AMENDMENTS TO DA APPROVED STUDIO

17 Old Sydney Road, Seaforth

**CALCULATIONS
REMAIN AS PER
APPROVED DA
NO: DA2021/1835**

DATE	DRAWN BY	REVISION	ISSUE	CUSTOMER SIGN	JOB REF
25/05/2022	AM	A	DA AMENDMENT		1349
			DESIGN DEVELOPMENT		
			CONSTRUCTION ISSUE

FLOOR PLAN

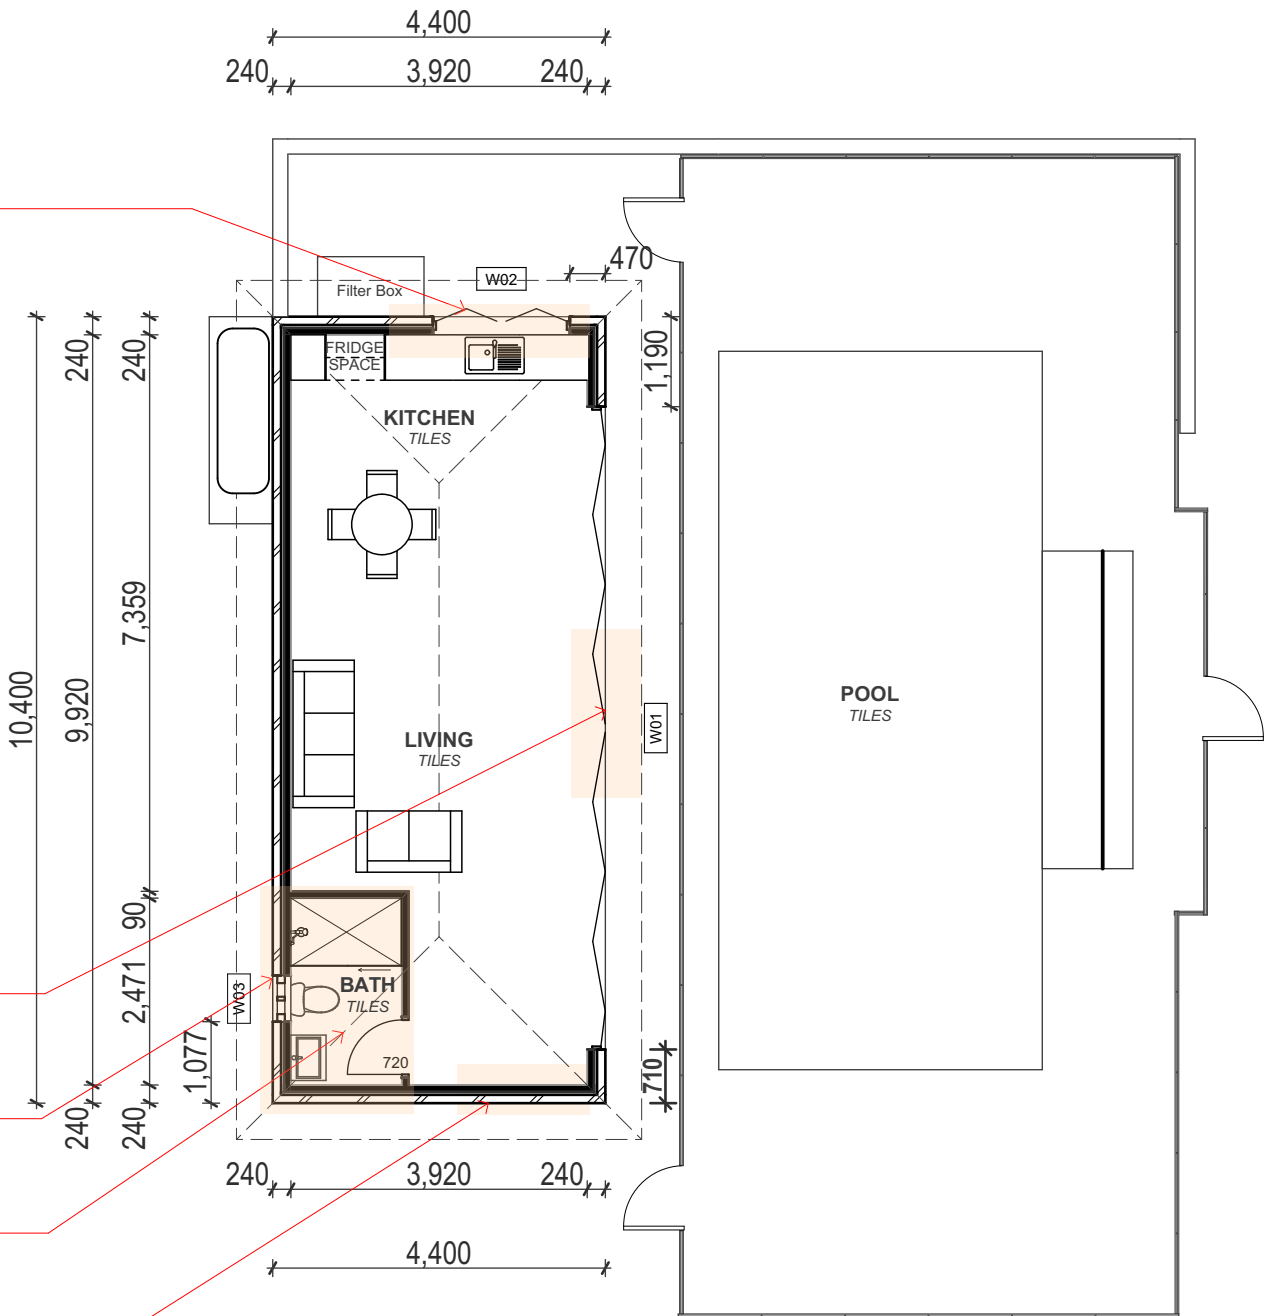
BIFOLD WINDOW MOVED TOWARDS FB
WIDTH CHANGED FROM
1370 mm TO 1810 mm (H 1029)

BATHROOM WINDOW MOVED
TO THE MIDDLE

BATHROOM LAYOUT
CHANGED

DOOR REMOVED
